FOREST LAKES FILING NO. 6

CONSTRUCTION PLANS

EPC STORMWATER REVIEW COMMENTS
IN ORANGE BOXES WITH BLACK TEXT

FOREST LAKES FILING NO. 6 CONSTRUCTION PLANS TITLE SHEET			
DESIGNED BY	MAL	SCALE	DATE 08/04/2020
DRAWN BY	MES	(H) 1" = N/A	SHEET 1 OF 25
CHECKED BY		(V) 1" = N/A	JOB NO. 1175.60

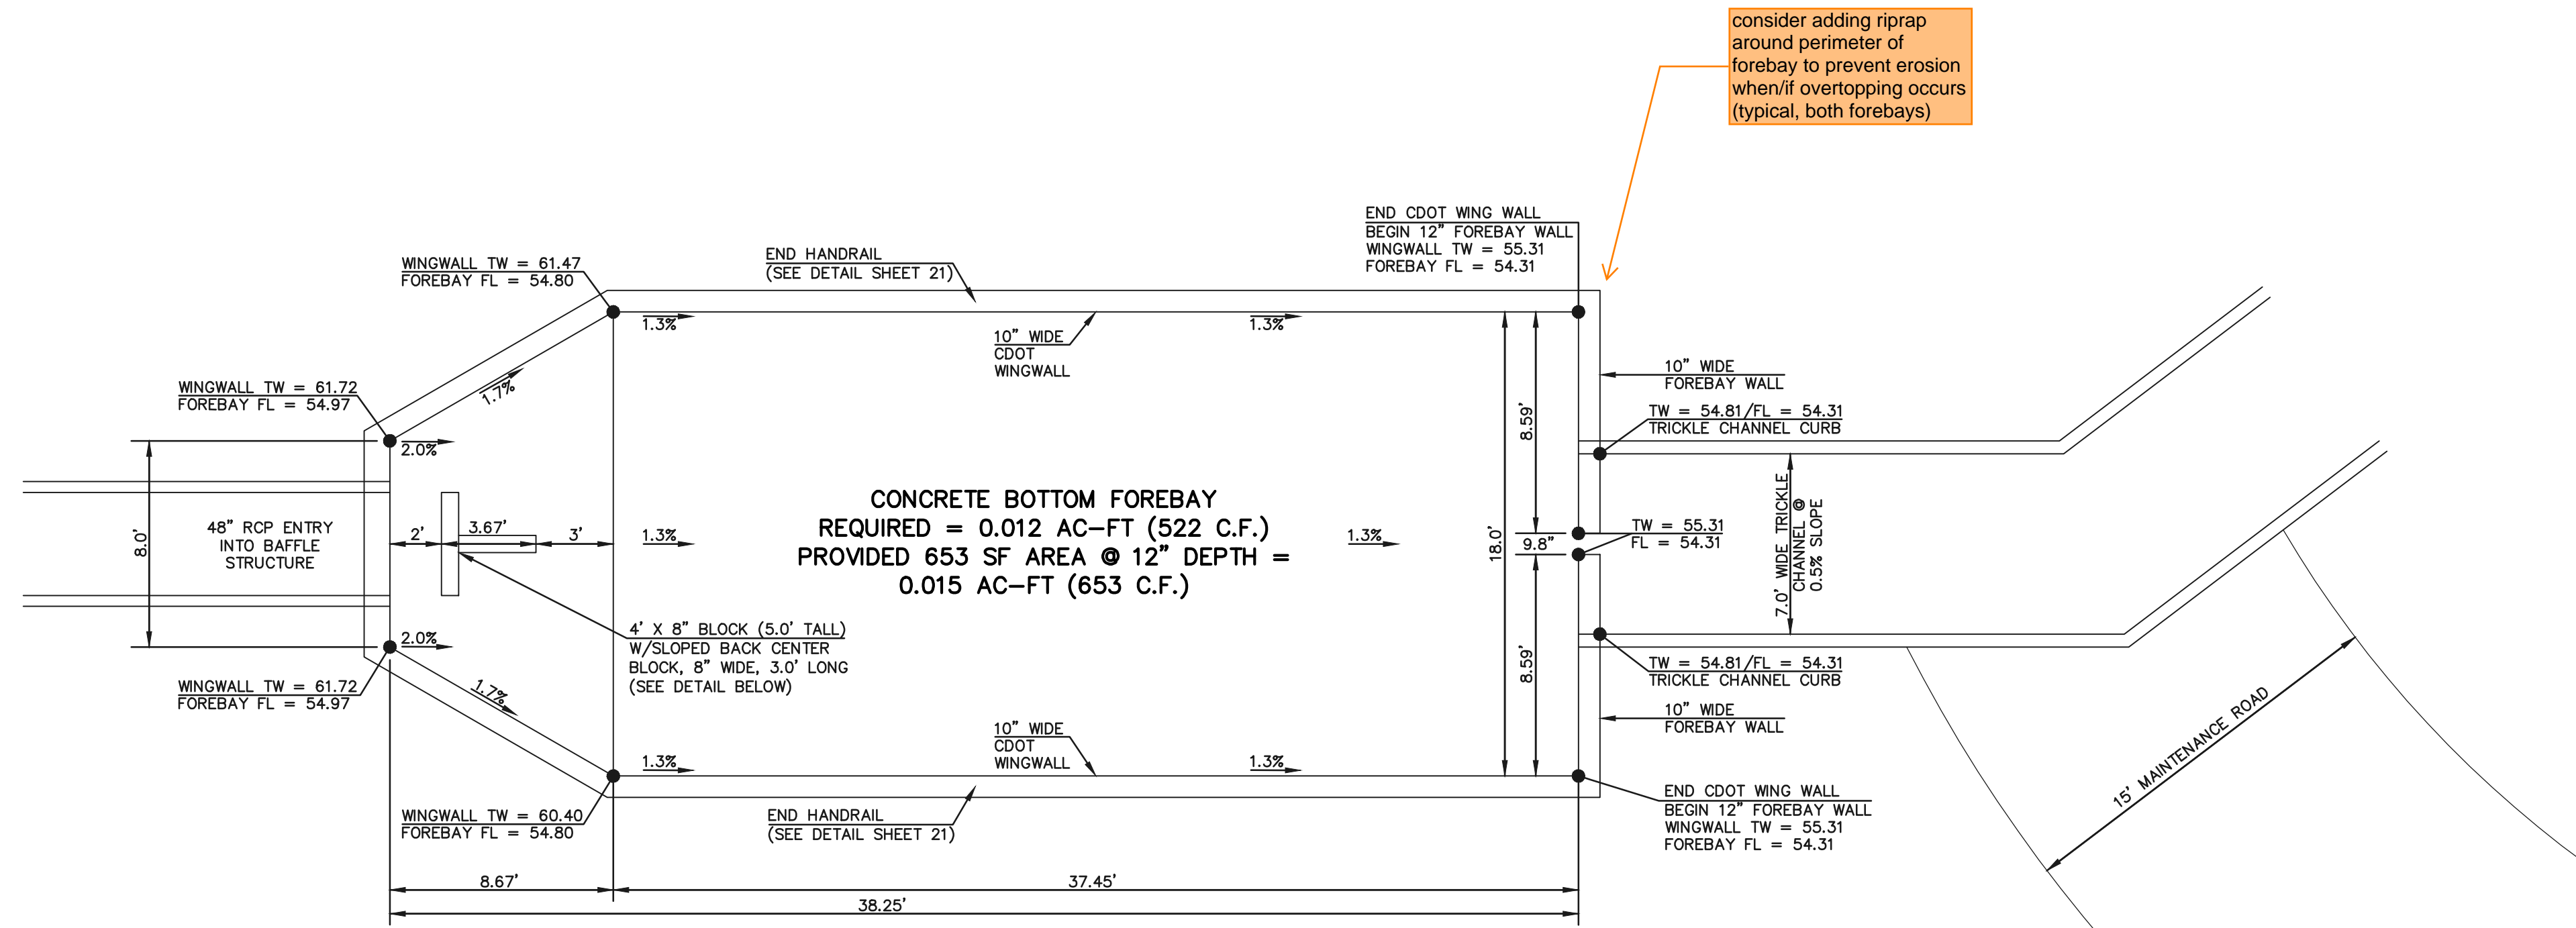
consider adding riprap around perimeter of forebay to prevent erosion when/if overtopping occurs (typical, both forebays)

MAIN 'H' 42" RCP FOREBAY & BAFFLE STRUCTURE - PLAN VIEW
SCALE 1" = 5'

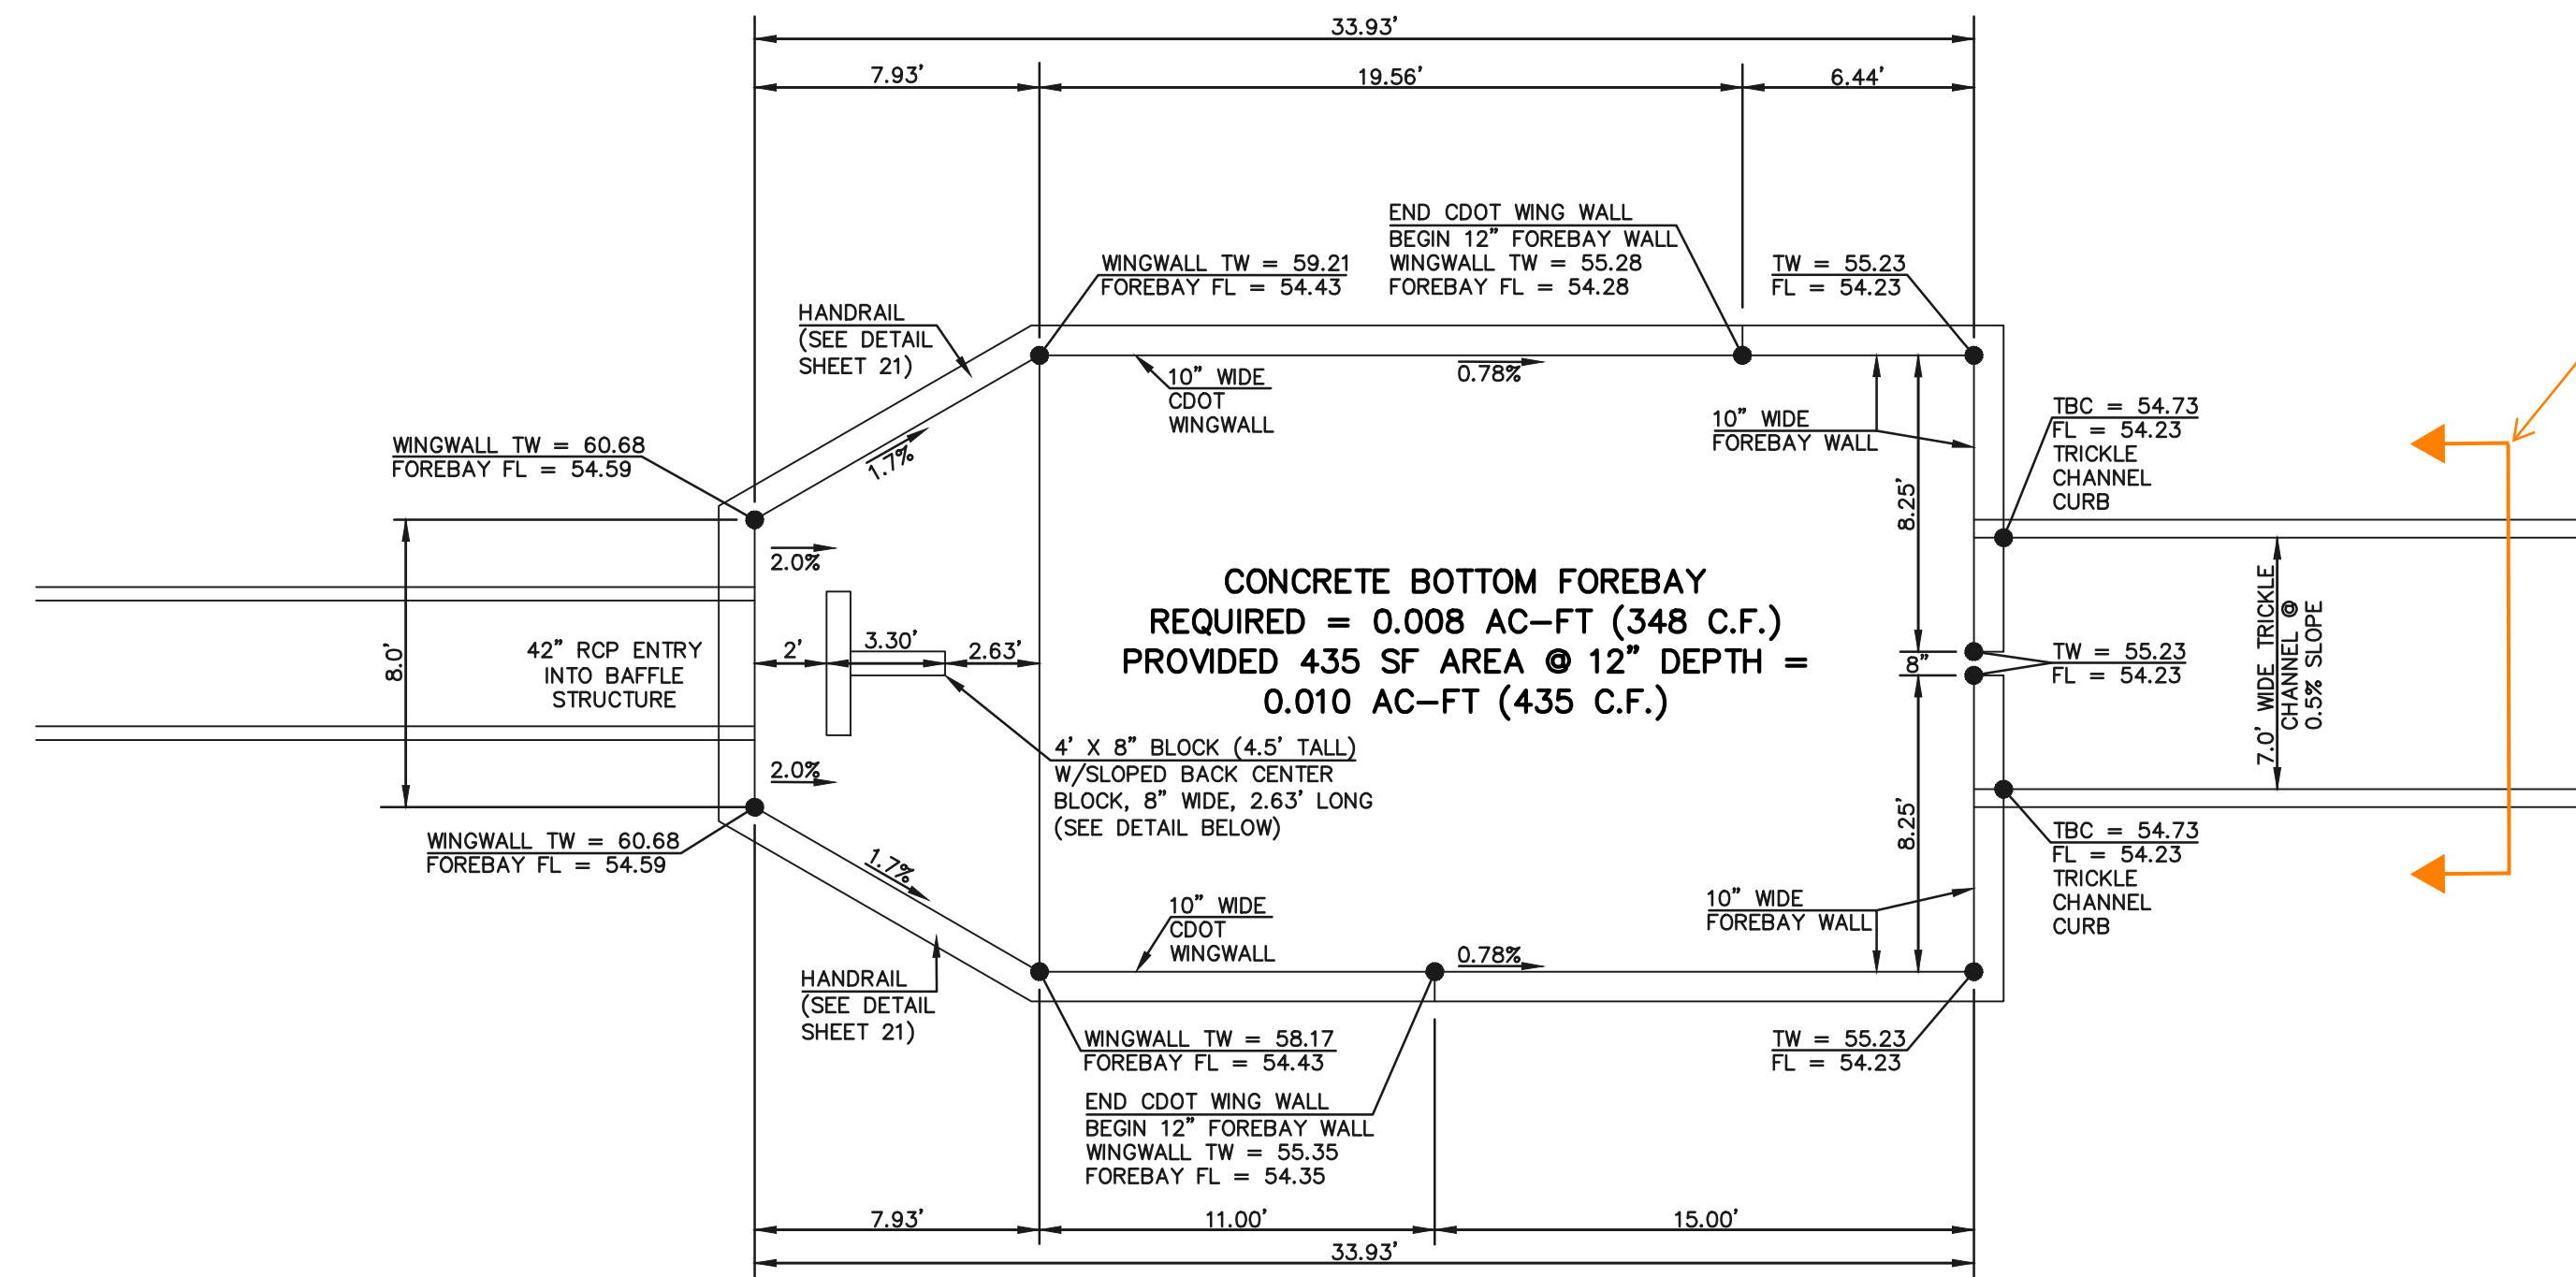
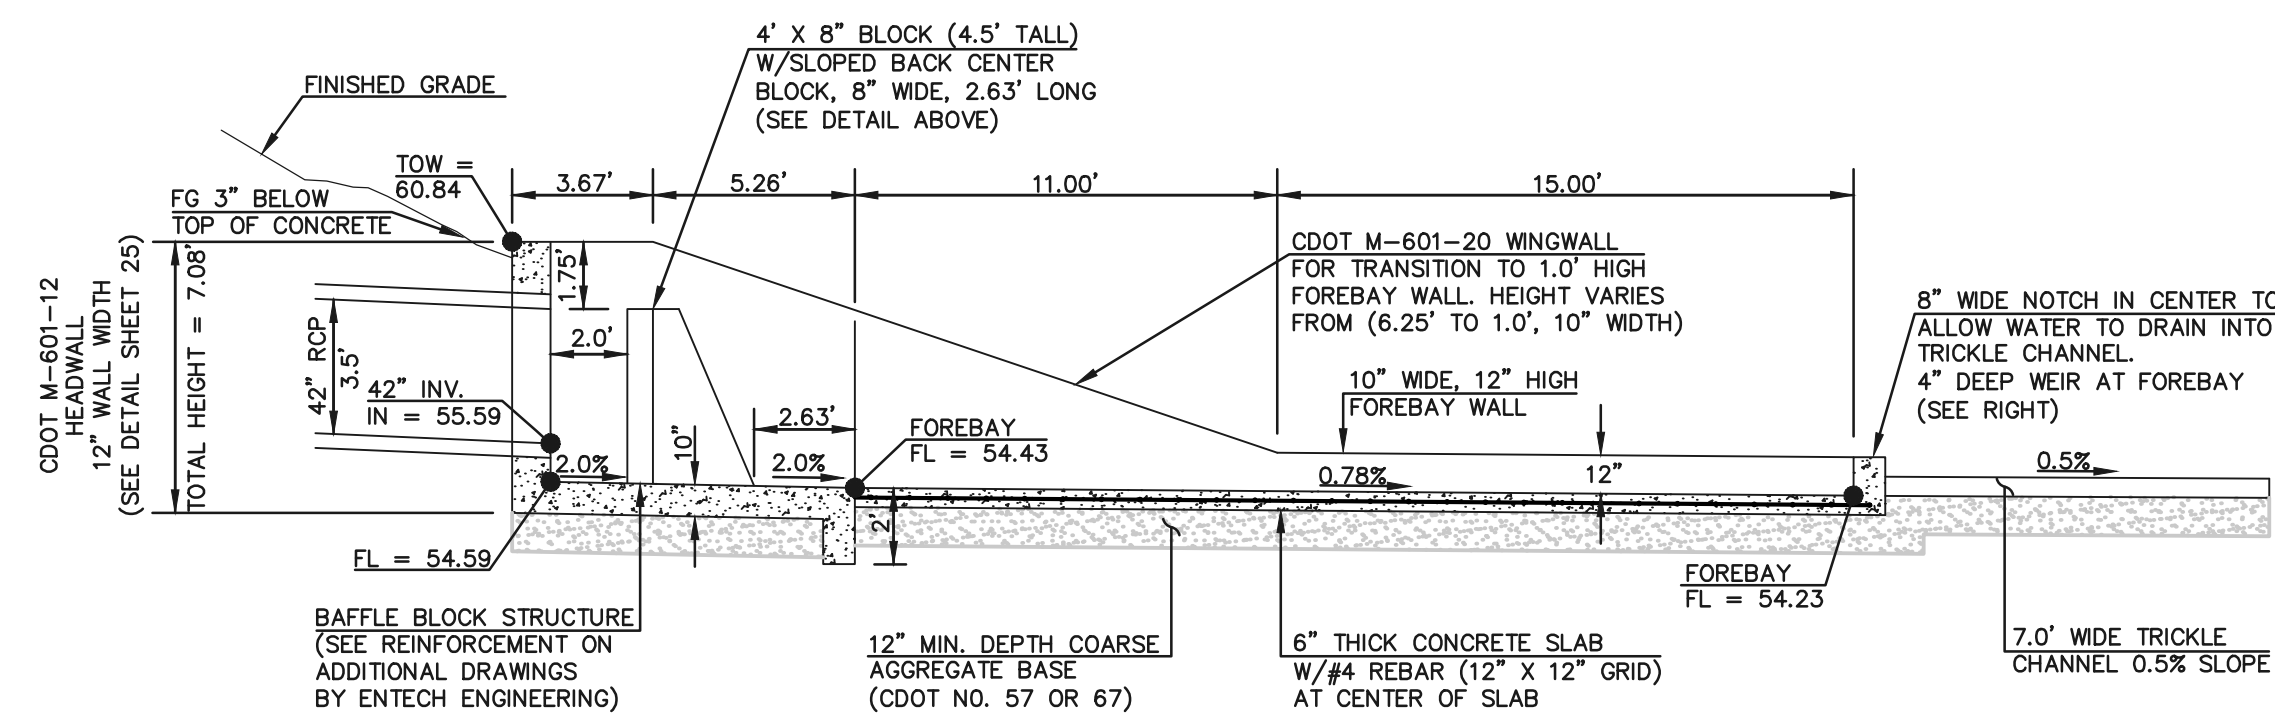
show typical section of trickle channel so it is clear how pond is graded to top of curb

**CDOT MANHOLES
STD. PLAN NO: M-604-20**

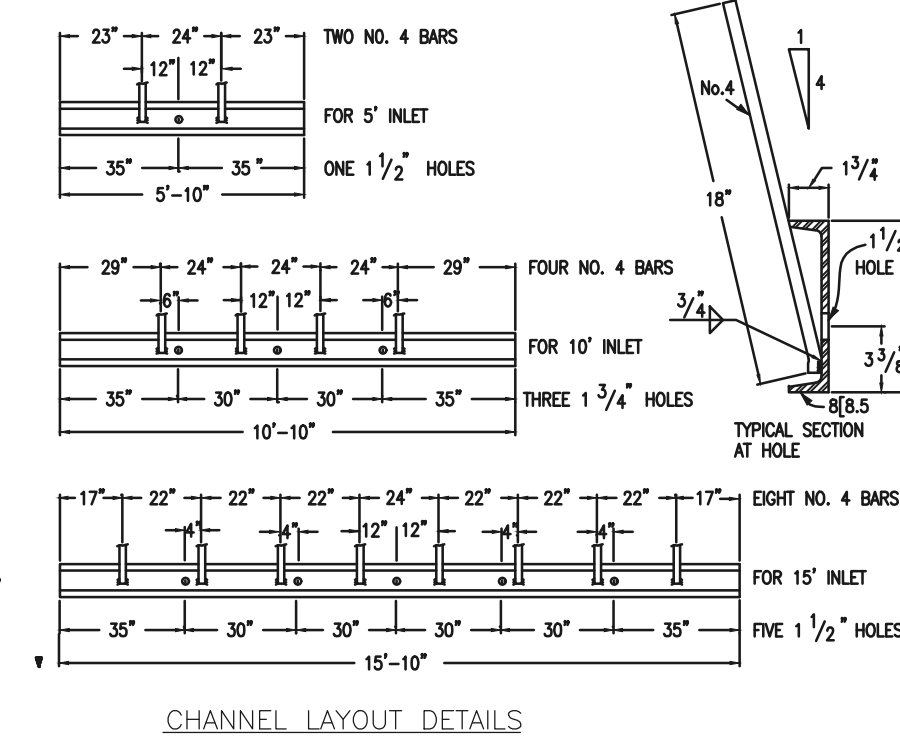
Replace manhole cover to EPC Detail SD_3-5
